Re: Response to request for further information in accordance with section 92 of the Resource Management Act 1991 for the North Projects.

Response to s92 request for further information

Attachment A – Indicative public transport network

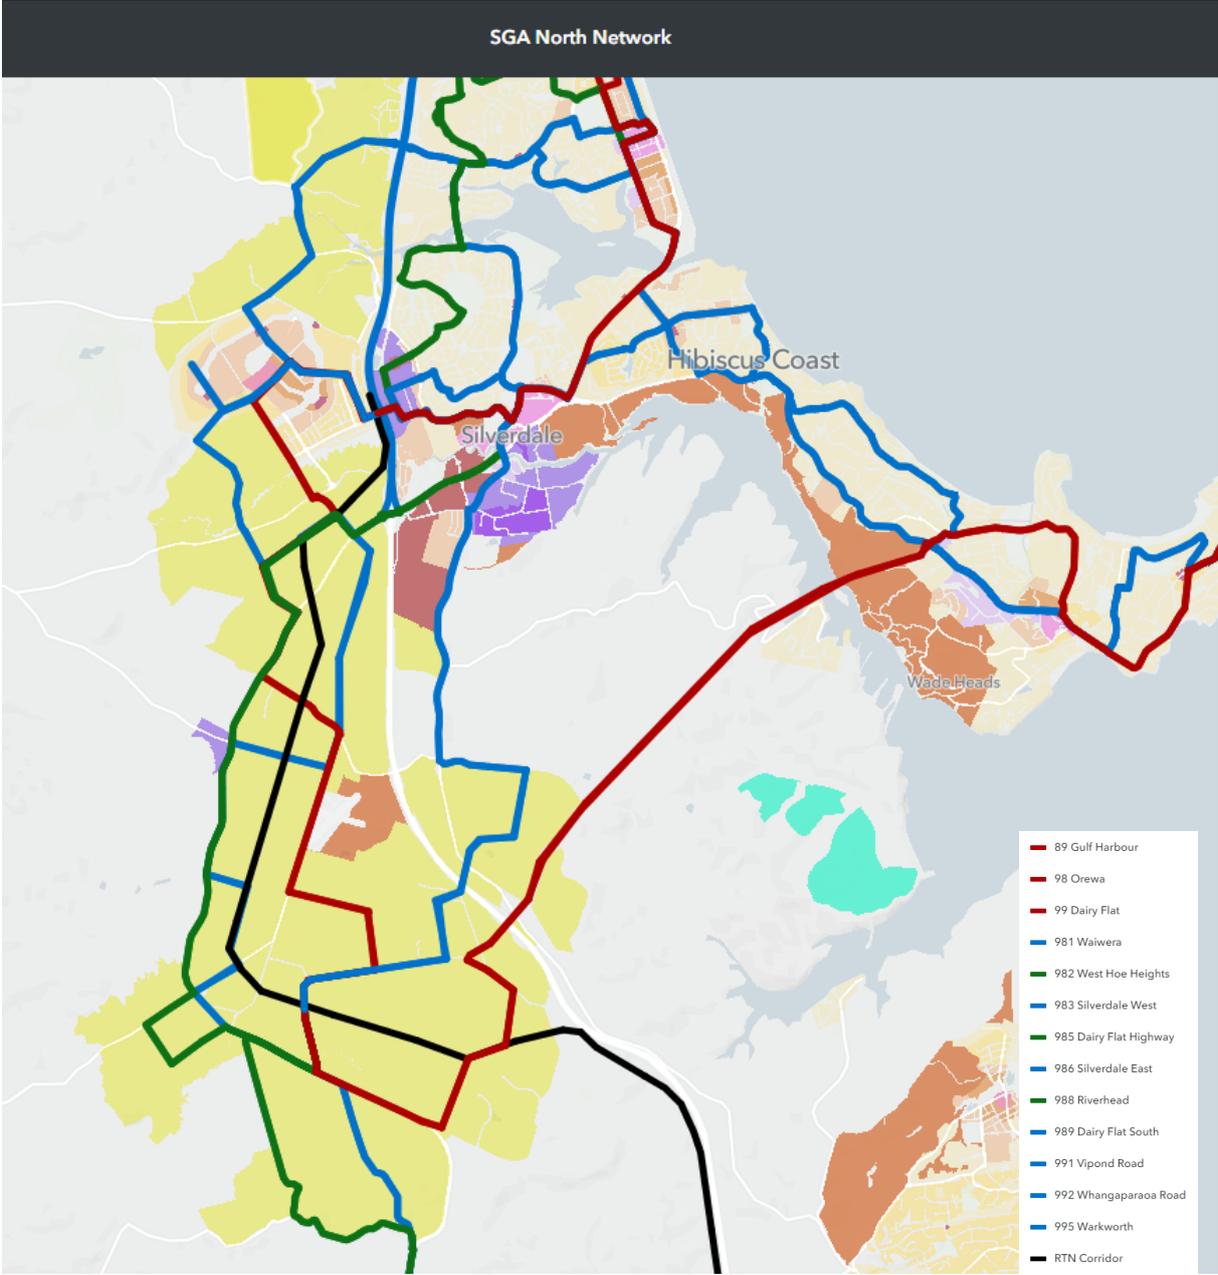
6	<p>Please provide details of the Remix file referred to in Section 3 of the ATE.</p> <p><i>Rationale:</i> Section 3 references a Remix file that has informed the public transport assessment. Please provide a copy of this file or provide a summary of inputs and outputs that have been relied upon.</p>	<p>Please find attached (refer Attachment A) the indicative public transport network that has been utilised to inform the North Detailed Business Case and subsequent NORs. This network has been developed in collaboration with AT and Waka Kotahi Subject Matter Experts. It should be considered as indicative only and provides for possible public transport (PT) service patterns and operational outcomes, based on the proposed transport network. This network is subject to change and variations in the future in response to a range of factors, such as staged delivery of the network and supporting collector routes, changes in land use assumptions, or operational funding availability.</p>

FOUR LANE ARTERIAL - 30M

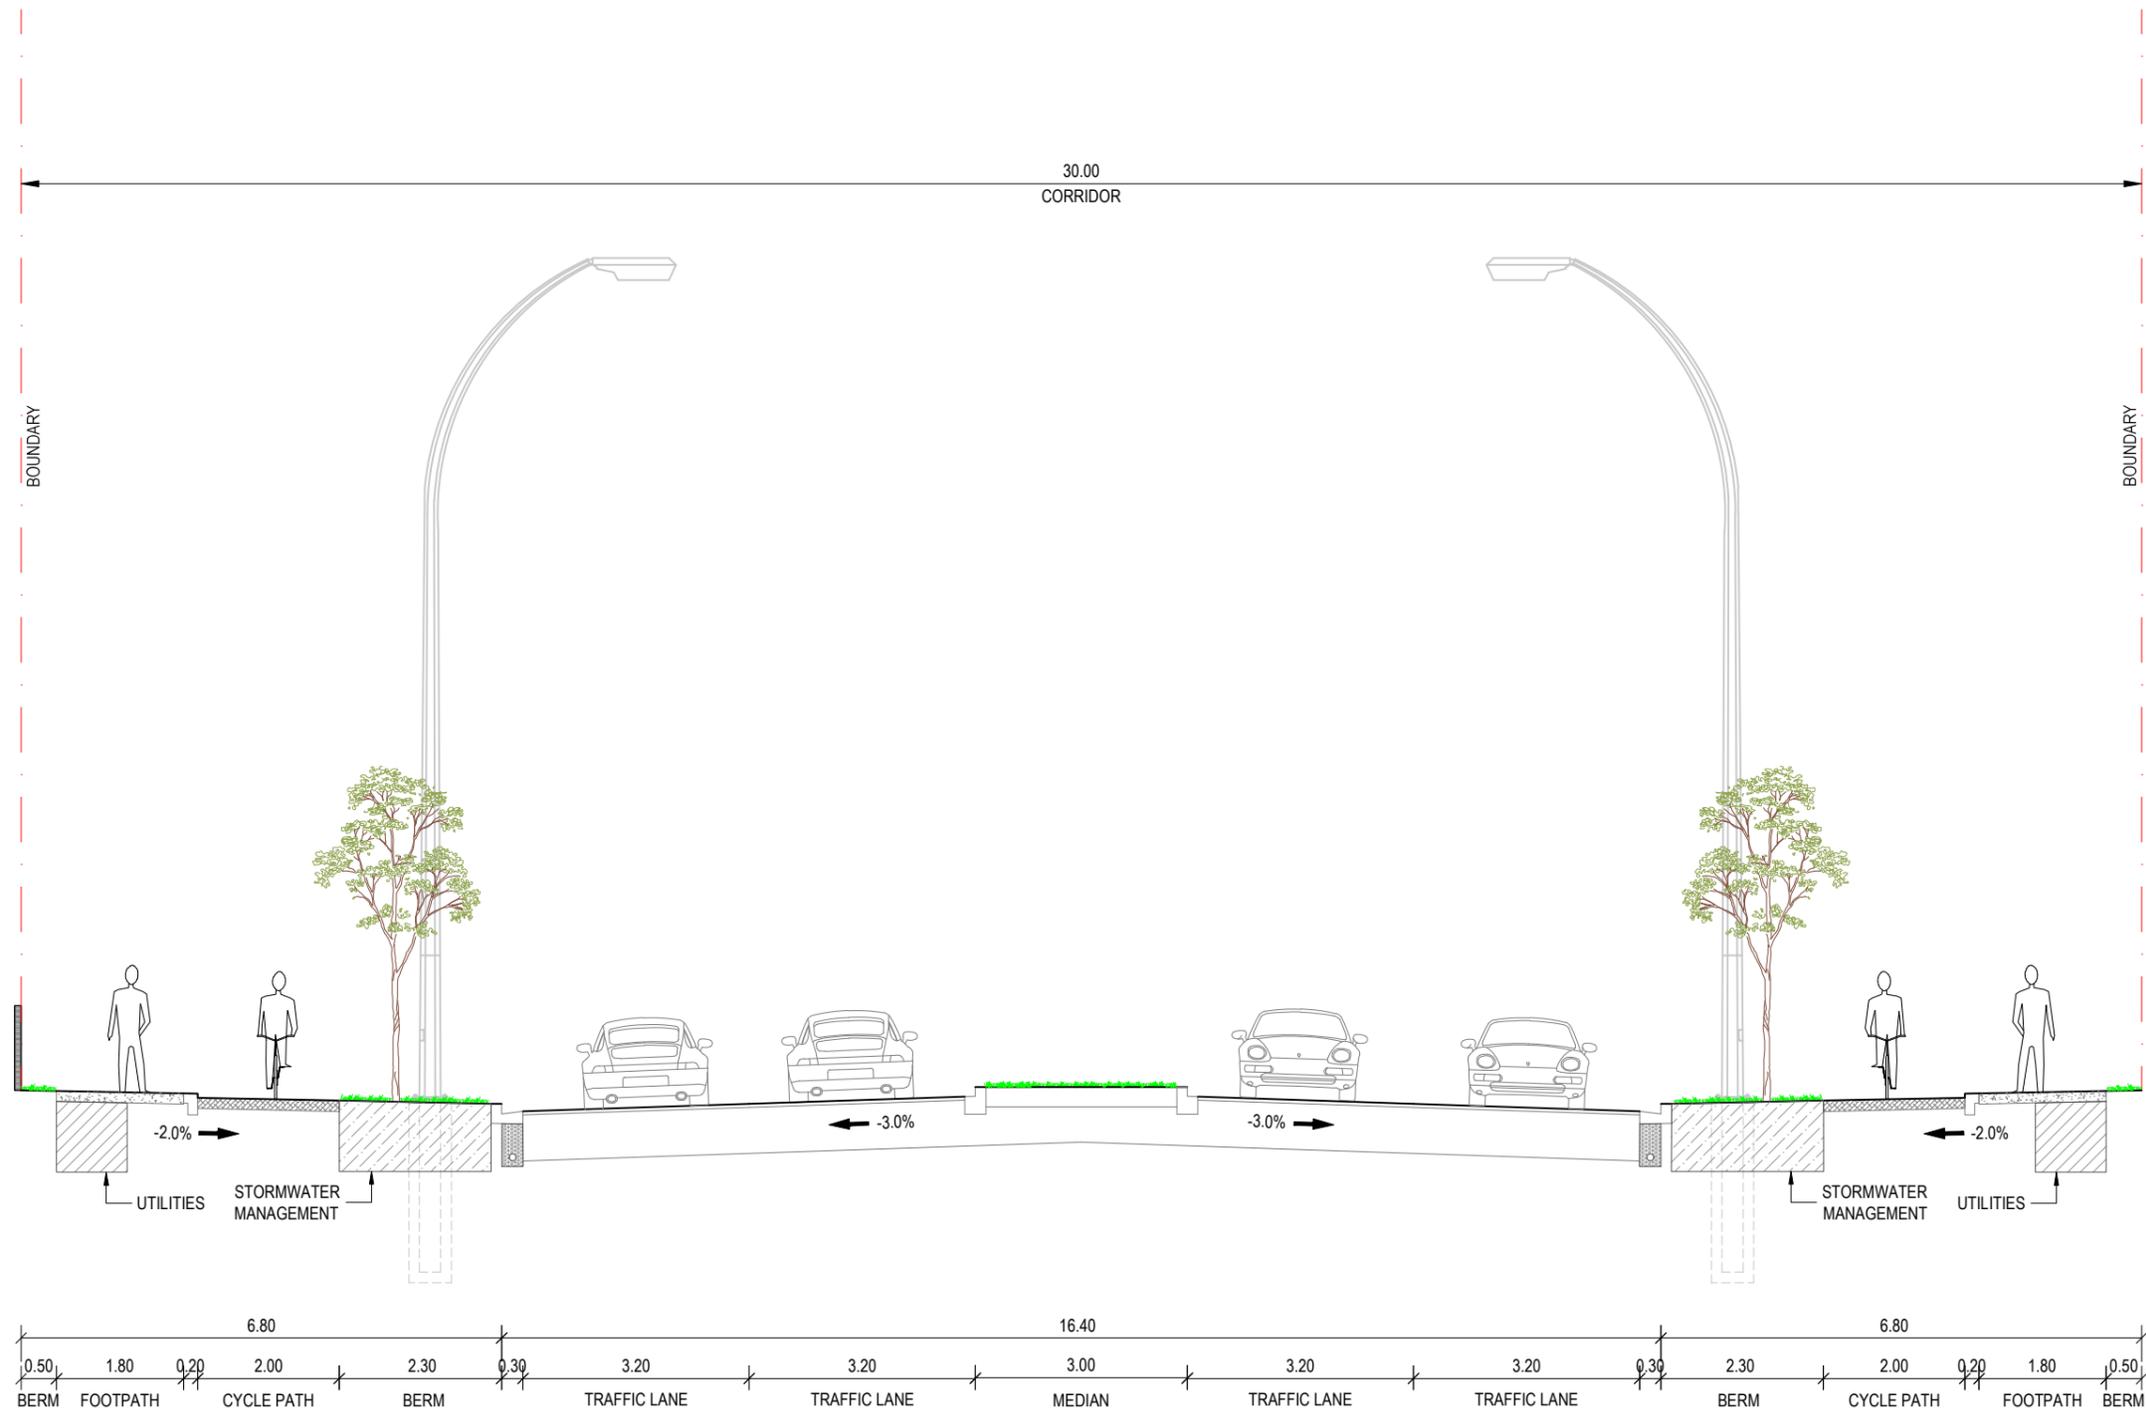
12	<p>Please provide dimensioned cross sections at key locations for each NoR.</p> <p><i>Rationale:</i> Cross sections for the proposed future corridors are provided in several sections of the report, however these do not include indicative dimensions.</p>	<p>No dimensions have been included within the cross-sections provided in the ATE report, as the exact configuration of the carriageways will be decided closer to the implementation of the projects. The specific requirements for the corridors may change slightly in the future based on what is needed during implementation. We note that there is sufficient width within the designations to provide for all the required modes.</p> <p>The cross sections also enable a variable berm environment with sufficient room to provide for bus stop infrastructure, such as shelters, at a location to be determined in the future.</p> <p>Notwithstanding this, we have attached indicative dimensioned cross sections (refer Attachment B), showing an indicative 24m 2-lane urban arterial, an indicative 30m 4-lane urban arterial and a 4-lane urban arterial with FTN, and an indicative 20m cross-section for the RTC with active modes. These have been developed to inform the designations, and will be reviewed at future implementation to align adjacent land use that exists at that time as well as to reflect standards at the time.</p>

Standard cross section to be used for arterials with no strategic PT function. Four lane cross section with FTN (below) should also be used for engagement to demonstrate that the additional lanes could be used for Public Transport in the future.
